marantz® SERVICE BULLETIN		Date: 27-Feb.-2004	Model: DV8400
		Page: 1 / 1	REF.NBR: MZ04-017
Circulation:		Subject:	
Application:		Output signal distortion.	
x for information customer complaint in case of service mandatory			
		See Below

marantz® SERVICE BULLETIN		Date: 15-May-2003	Model DV8400
		Page: 1/1	REF.NBR: MZ03-016
Circulation:		Subject:	
Application:		1. Slow mode problem	
x for information customer complaint in case of service mandatory		2. RC232C command problem in the condition of "No Disc."	
Before MZxxxxxx02xxxx		Int.ref:

On the PM01-AV CIRCUIT BOAD

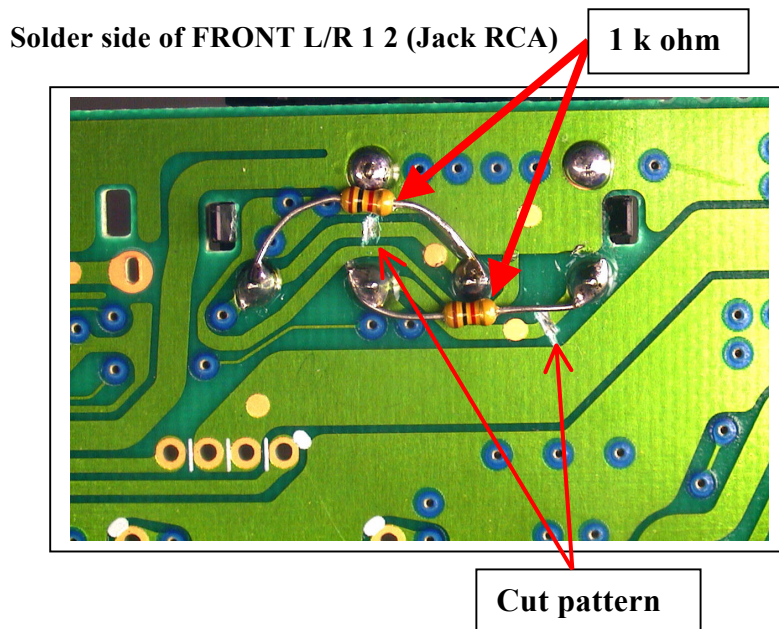
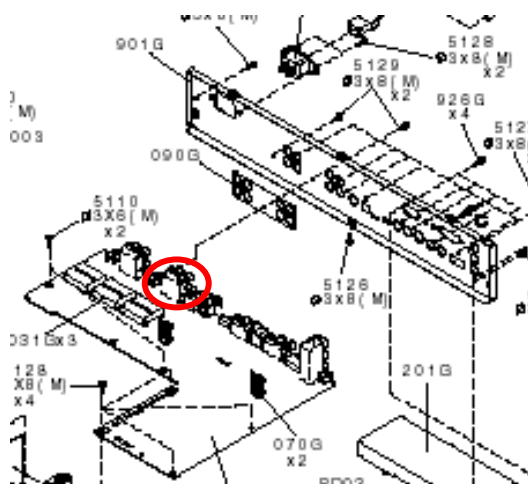
- 1) FRONT L/R 1 2 and SURR.L/R, CENTER L/R, SUB W L/R of AUDIO OUTPUT are simultaneously Connected to amplifier.
- 2) If the Amplifier which used the electronic switch is turned off, another sound will be distorted.

FRONT L/R 1 2 are connected parallel, therefore, if the Amplifier input of another side short-circuits, it will influence

1. Resistor 1k ohm is added to 2 of FRONT L/R 1 2.
2. Cut pattern.

Carbon film fixed resistor, 1k ohm +5% 1/6W (part no. **GD05102160**)
